Subject: AP1000 Response to Request for Additional Information (SRP 3)

RAI-SRP3.7.1-SEB1-10 R2

Response to Request for Additional Information on SRP Section 3

RAI Response Number: RAI-SRP3.7.1-SEB1-10

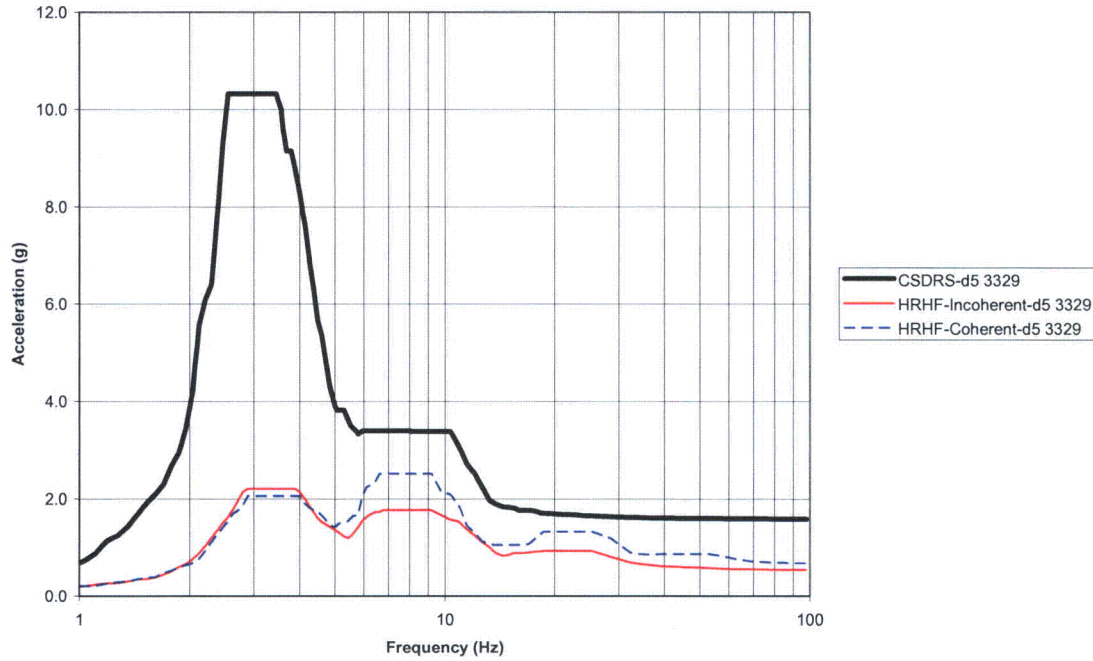
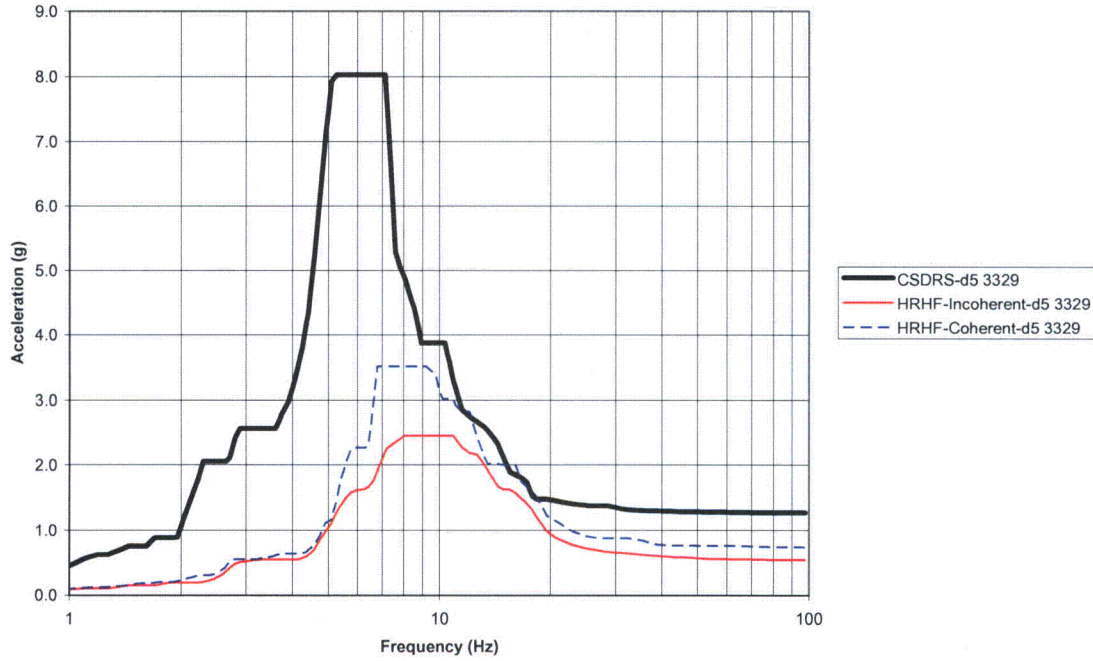
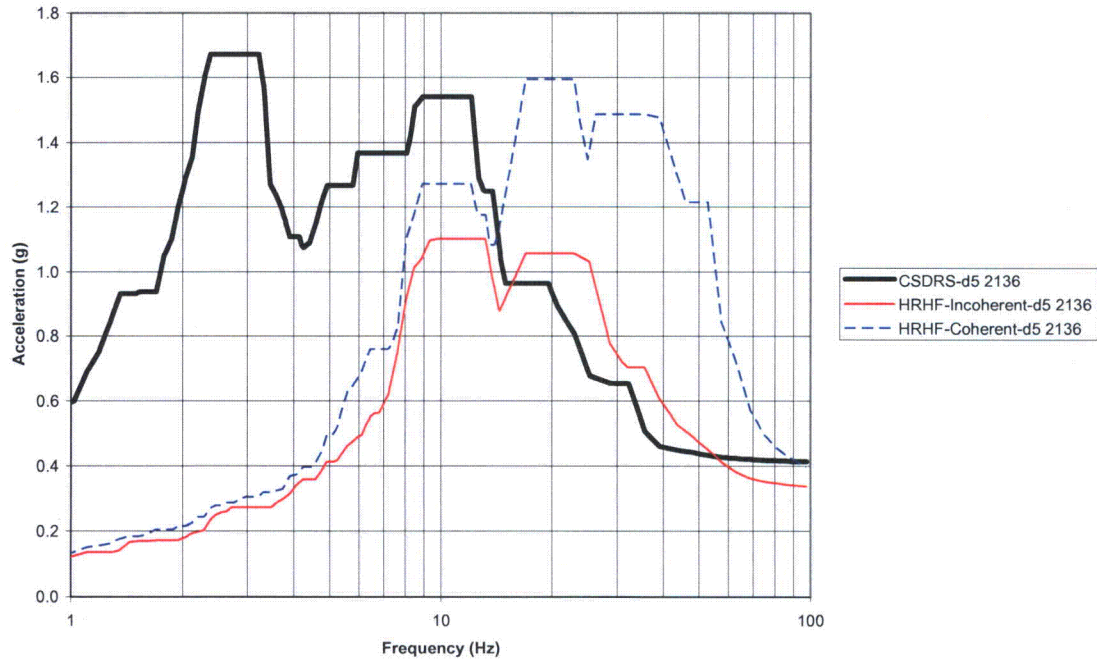
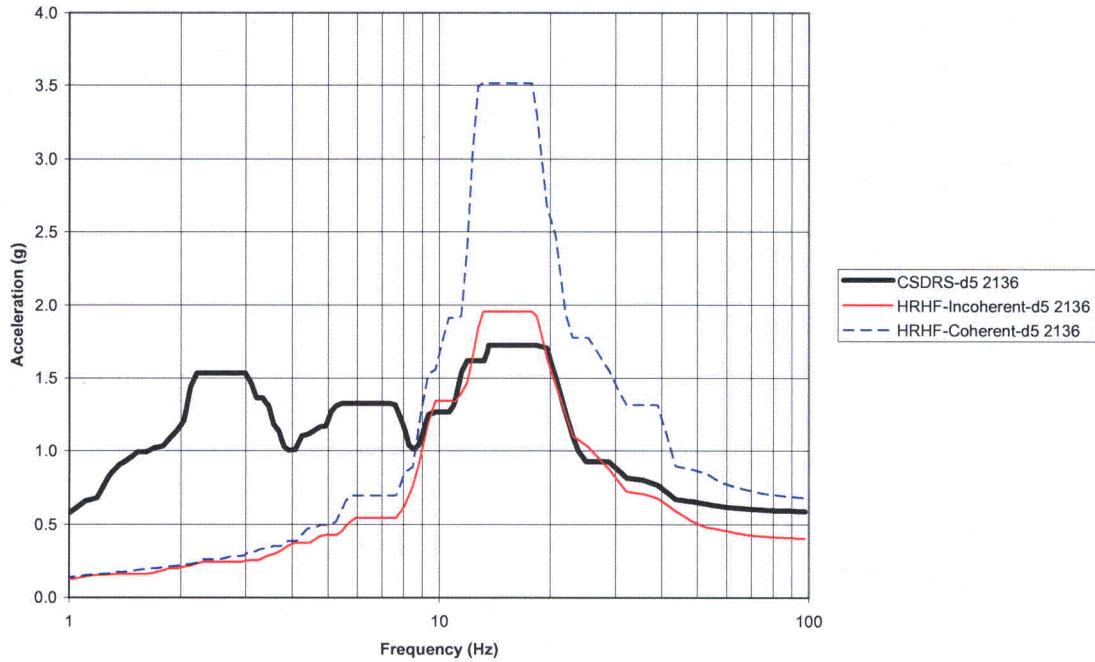
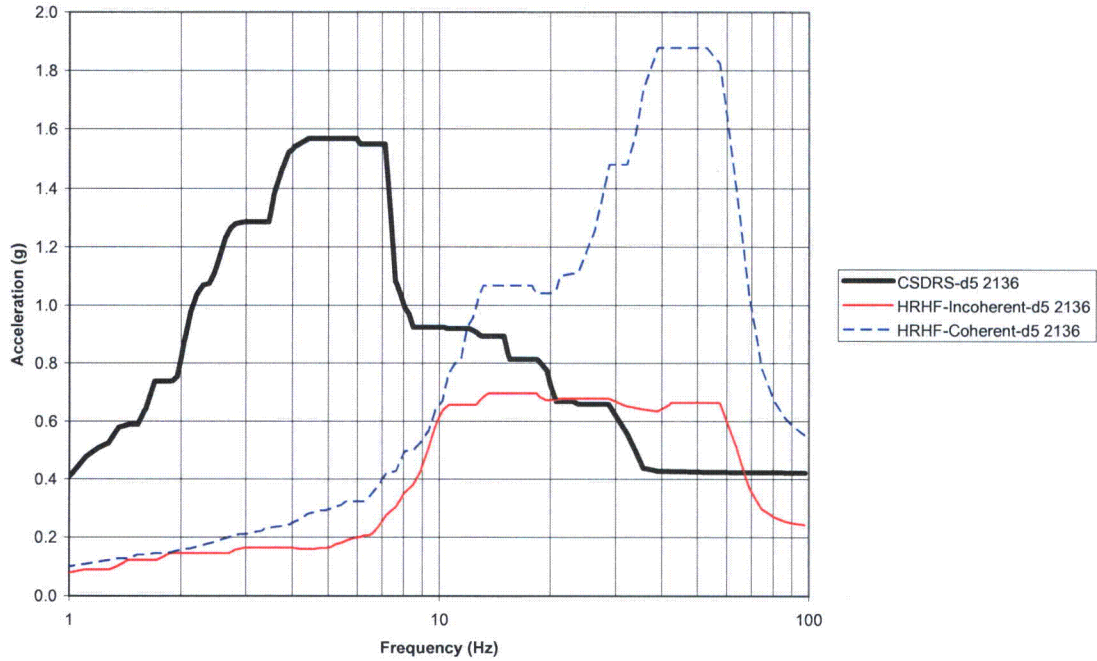
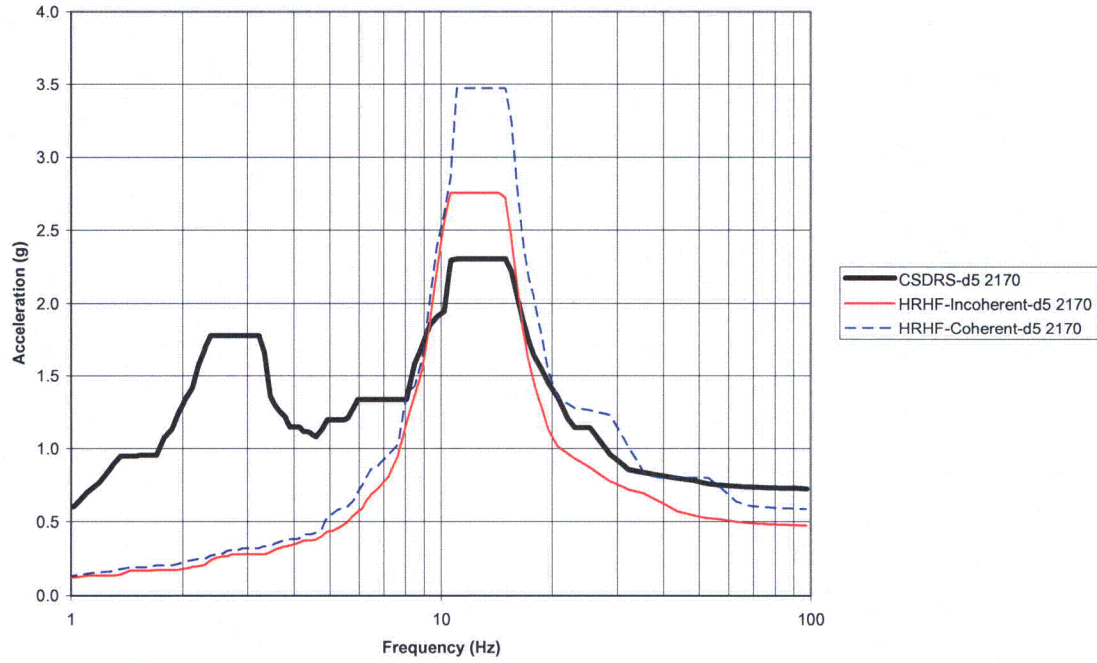
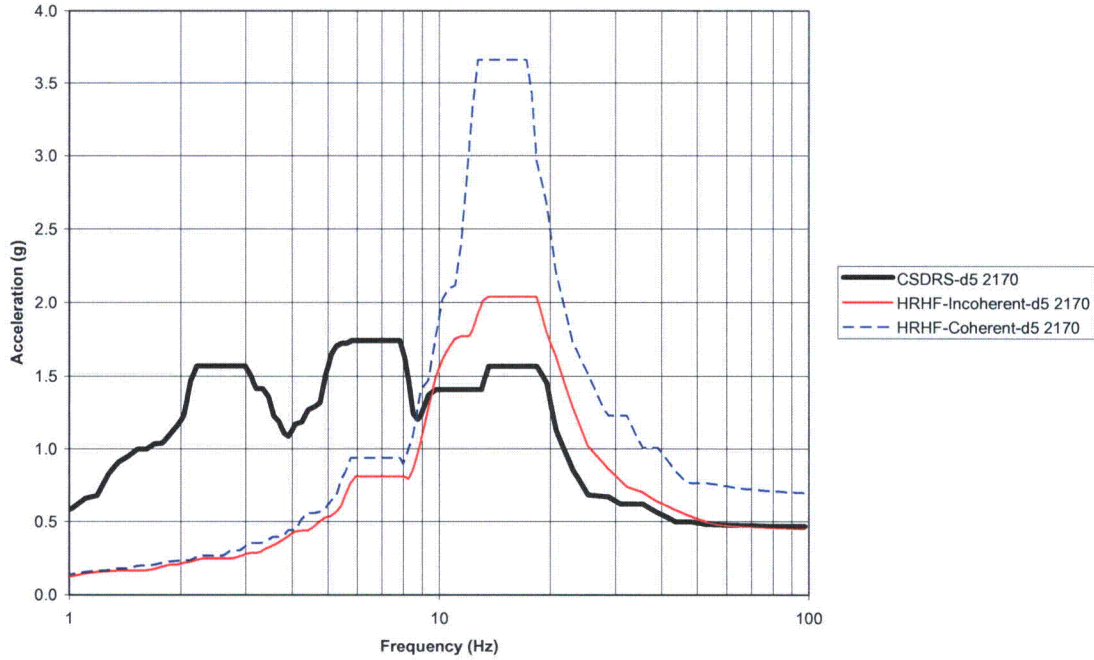
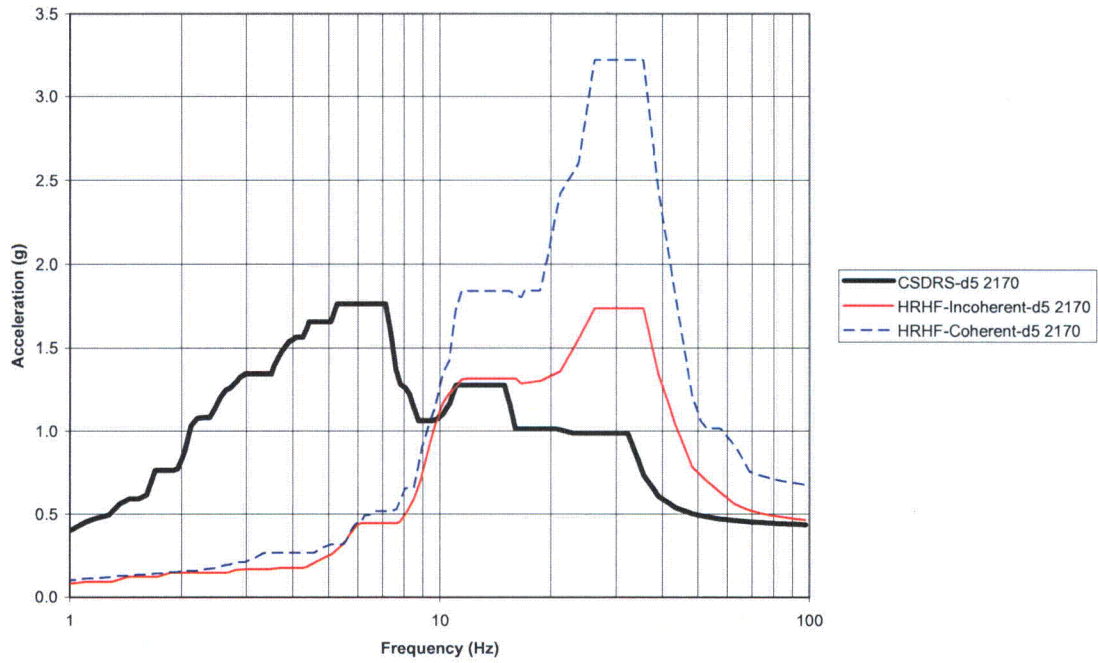
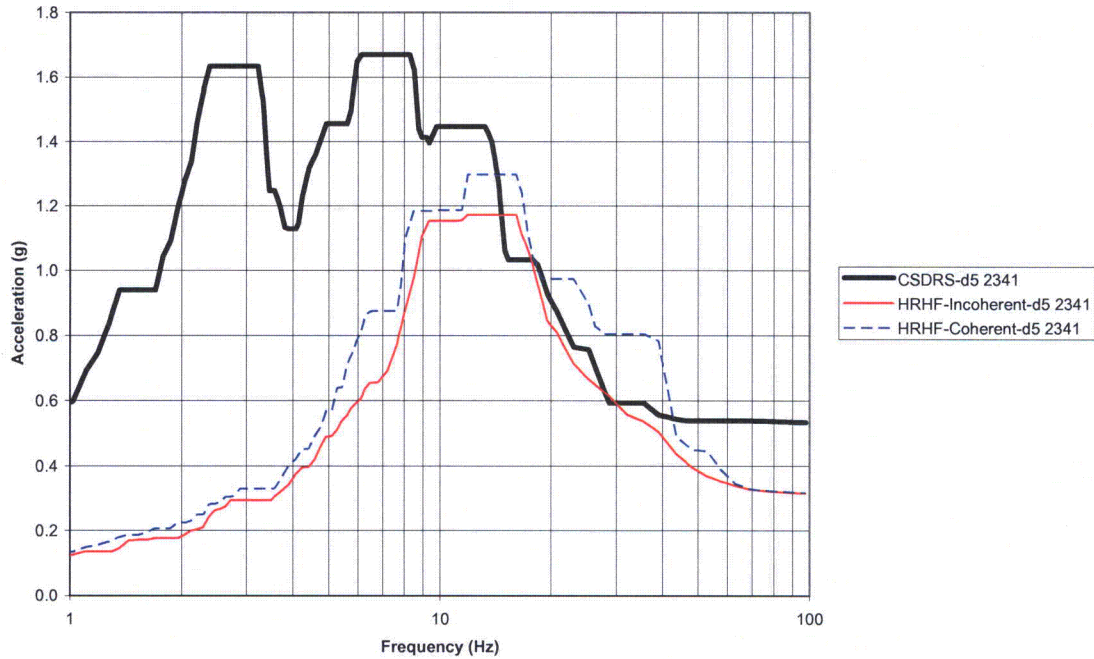
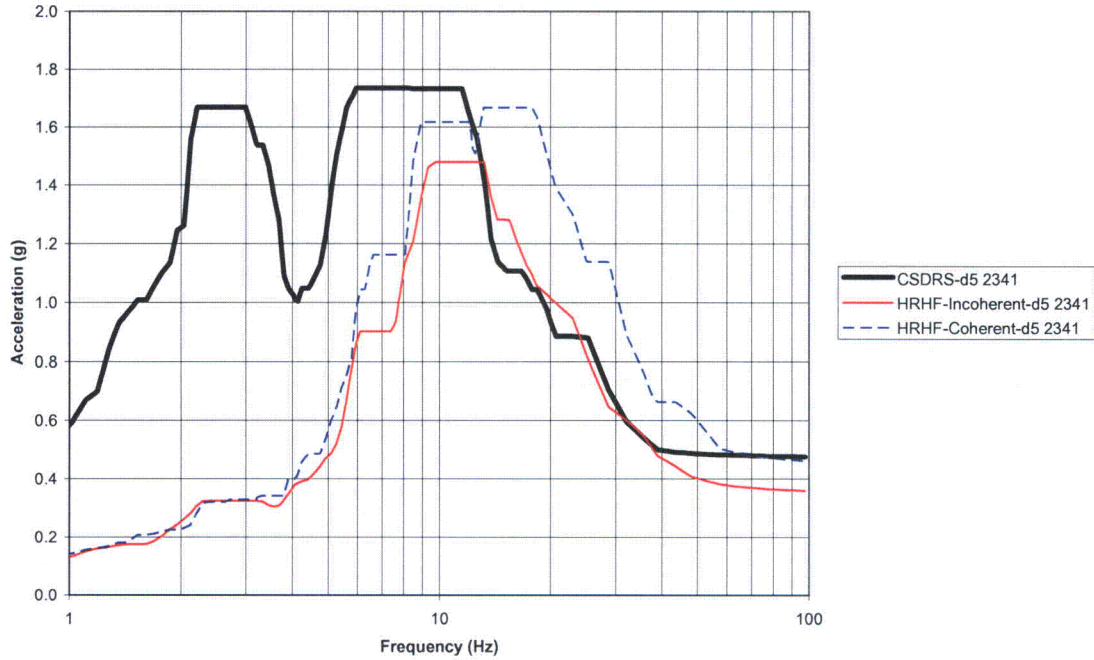
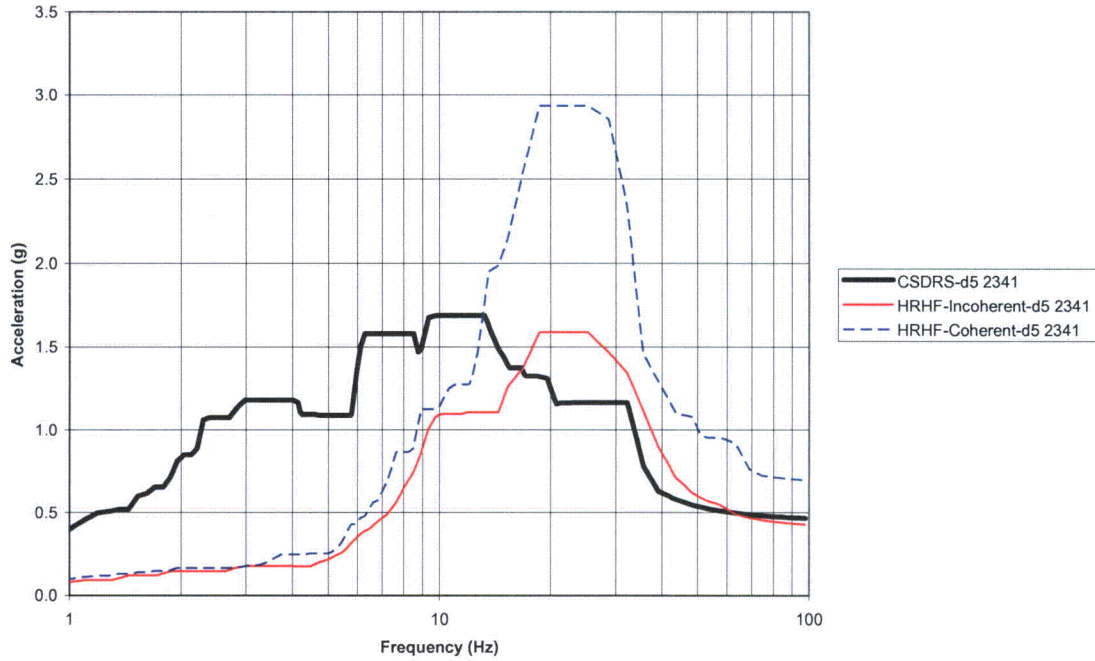
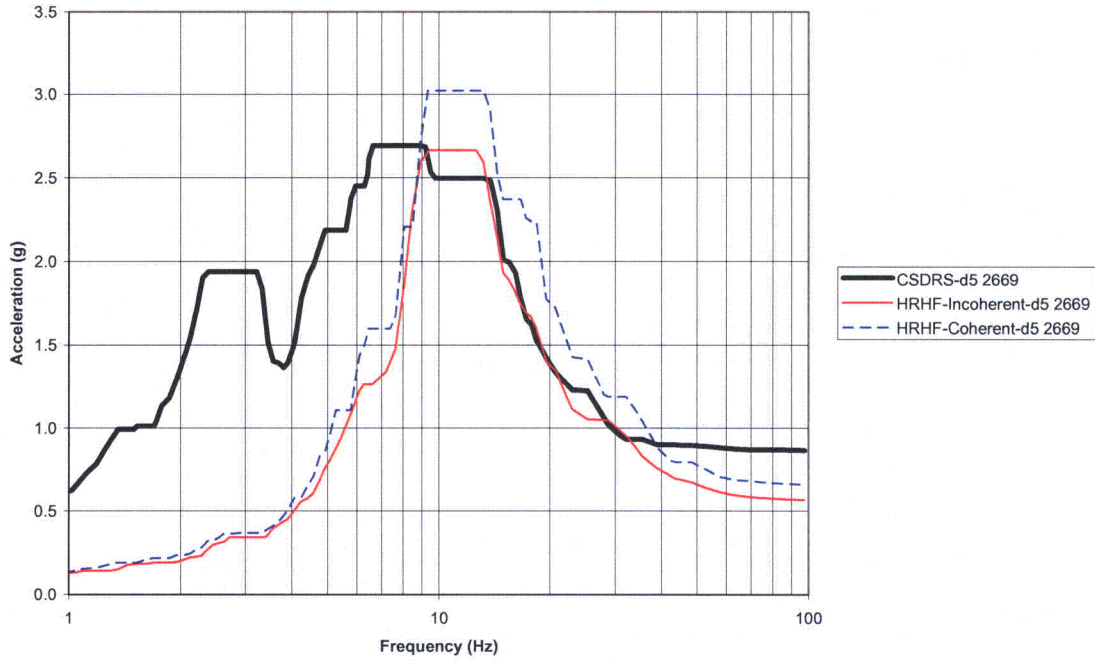
The staff requests that Westinghouse augment Figures 5.2-1 through 5.2-6 in TR-115, by adding the HRHF broadened spectra from the NI20 fixed base analysis, without any reduction for incoherency or other considerations. This will provide the staff with results needed to conduct an evaluation of the effect of incoherency.

In Figures RAI-SRP3.7.1-SEB1-10-1 to RAI-SRP3.7.1-SEB1-10-21 some of the reductions ratios (defined as Incoherent response / coherent response) are shown to be less than 0.5 in some cases. Analyses have been performed using the EPRI model to provide the staff with additional results needed to conduct an evaluation of the effect of incoherency. The results show that the size and shape of the basemat has a significant effect on the reductions obtained from incoherence.

In response to the question raised by the NRC during May 19-23, 2008, Westinghouse has provided the response spectra for the HRHF broadened NI20 model with coherent and incoherent considerations in Figure RAI-SRP3.7.1-SEB1-10-1 to RAI-SRP3.7.1-SEB1-10-21 (5% damping).

**Technical Report (TR) Revision:** The Figure RAI-SRP3.7.1-SEB1-10-1 to RAI-SRP3.7.1-SEB1-10-21 will replace Figure 5.2-1 through 5.2-6 in TR-115. See also RAI-SRP3.7.1-SEB1-11 for changes to Section 5.2.
